MANUFACTURING CHANGES:

Title: Quad Linear Amplifier Heatsink		Johns Hopkins University Laboratory for Computational Sensing and Robotics	
Date: 8/27/2012	Rev: 3		
File: HeatSink Rev3.PcbDoc		Sheet 1 of 1

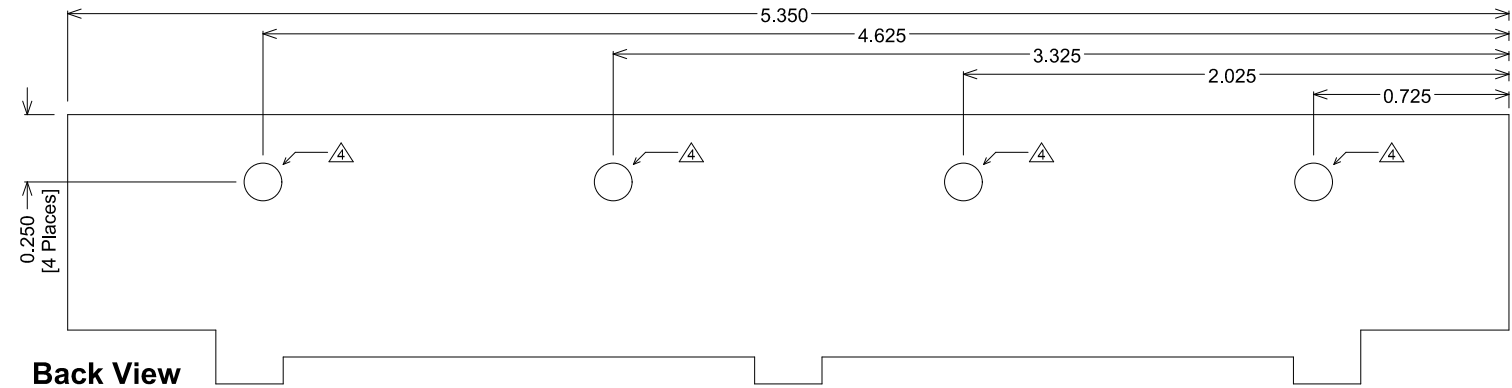
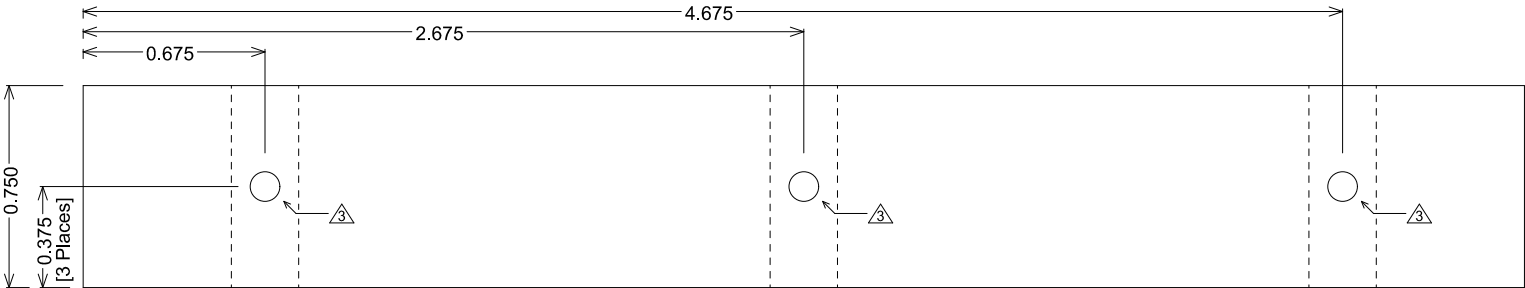
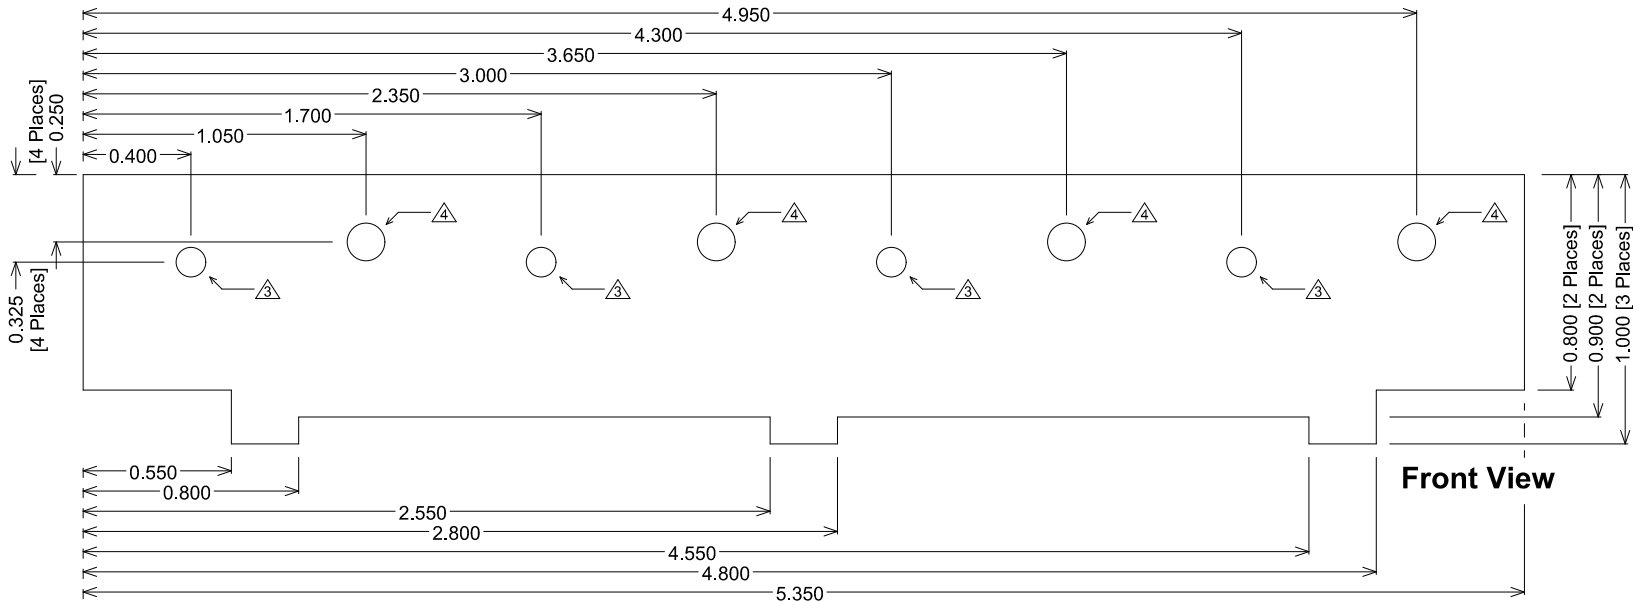
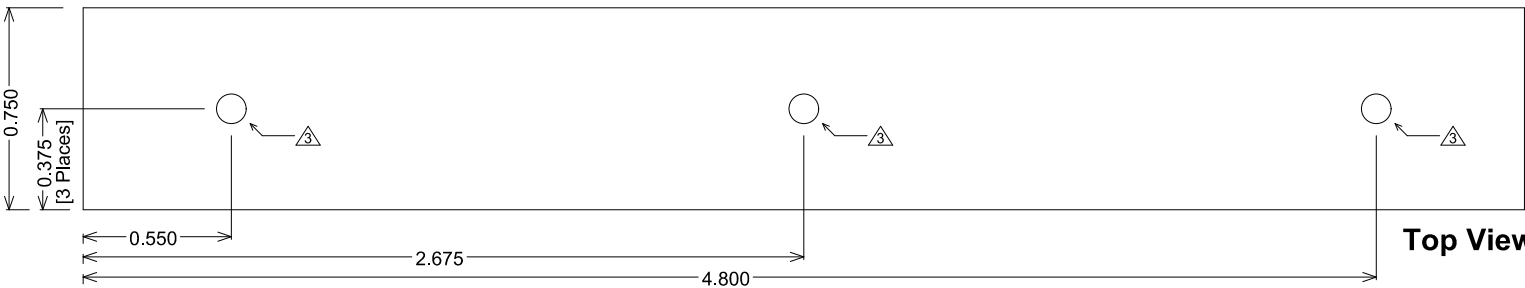
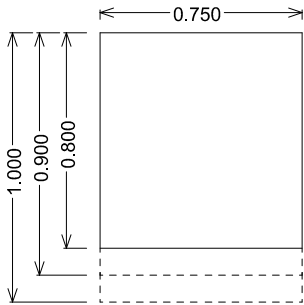
Build #2 (2013): M3 and M4 holes changed to 4-40 and 6-32, respectively, to match BOM

Build #3 (2014): M4 screws damaged OPA549 op amps; heat sink reworked to accept 6-32
